Fwd: Coal Hollow wells to east of HWT 2 experiencing drawdown

Coal Hollow Weekly Highwall monitoring June 16, 2014 to August 14, 2015

Figure 1: Location of C2, C3, and C4 series wells in south lease area of Coal Hollow.

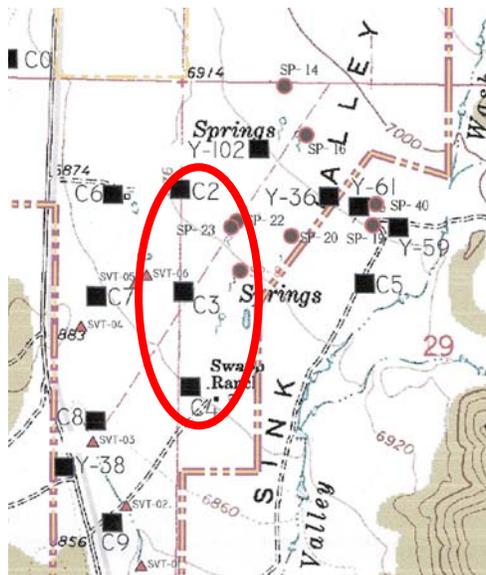
C2 wells are ~100 yds from edge of setback for Pit 10.

C3 wells are ~75 yds from edge of setback for highwall trench 2

C4 wells are ~200 yds from edge of setback for highwall trench 2 ½

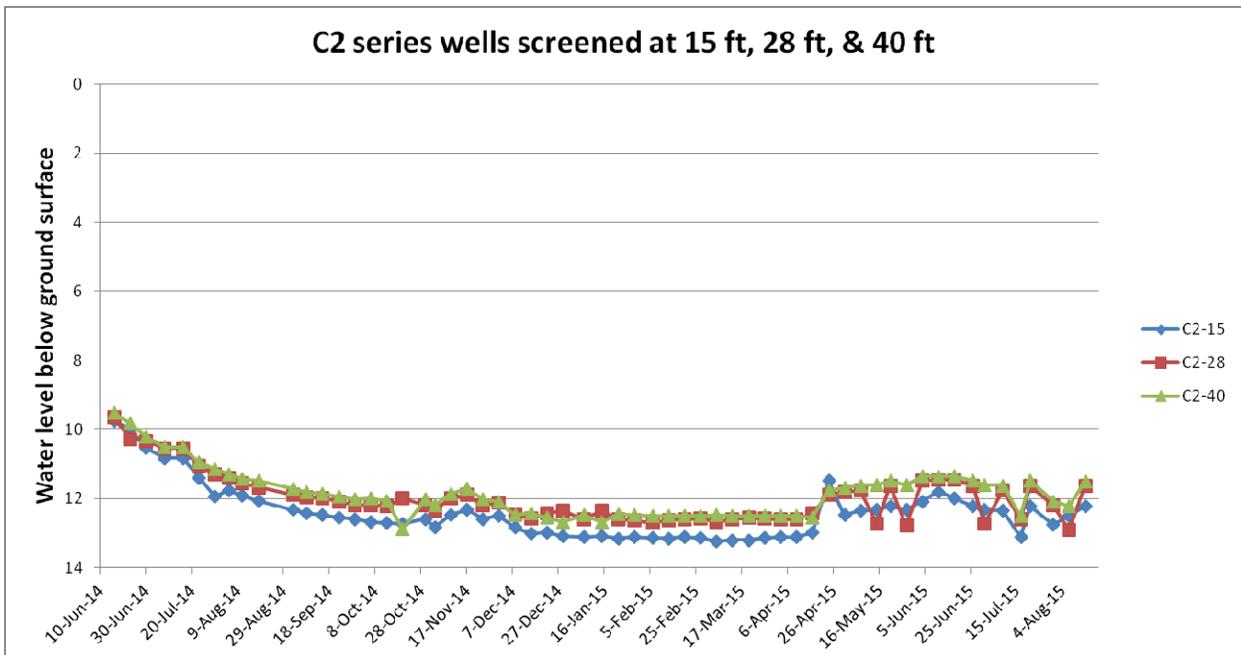
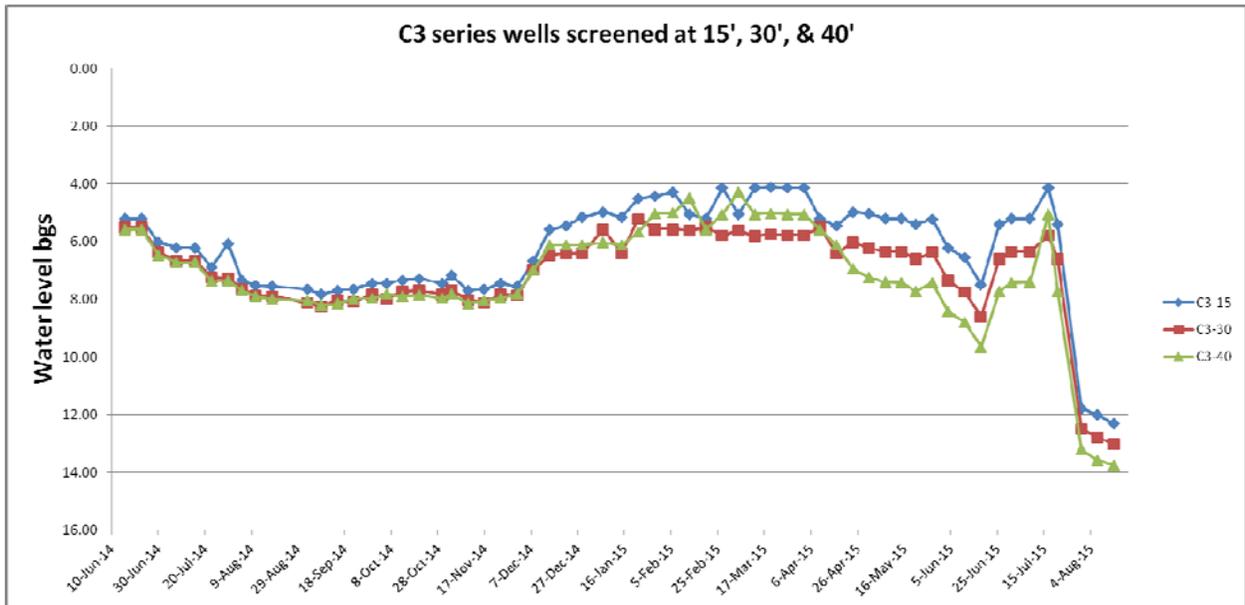
The C3 and C4 well groups have experienced a dramatic drop in water levels beginning in mid-July 2015 and the water levels have not recovered (see graphs below). This drop is most likely caused by the nearby mining activity where the shallow alluvial aquifer is allowed to drain into HWT 2. The group of monitored springs with water rights do not appear to be experiencing a loss in flow due to the highwall mining activities. This is not to say that they may experience a loss in flow in the future. The wells showed a roughly one month delay in response to mining activities because of the aquifer's low hydraulic conductivity, so the springs may see reduced flow in the near future.
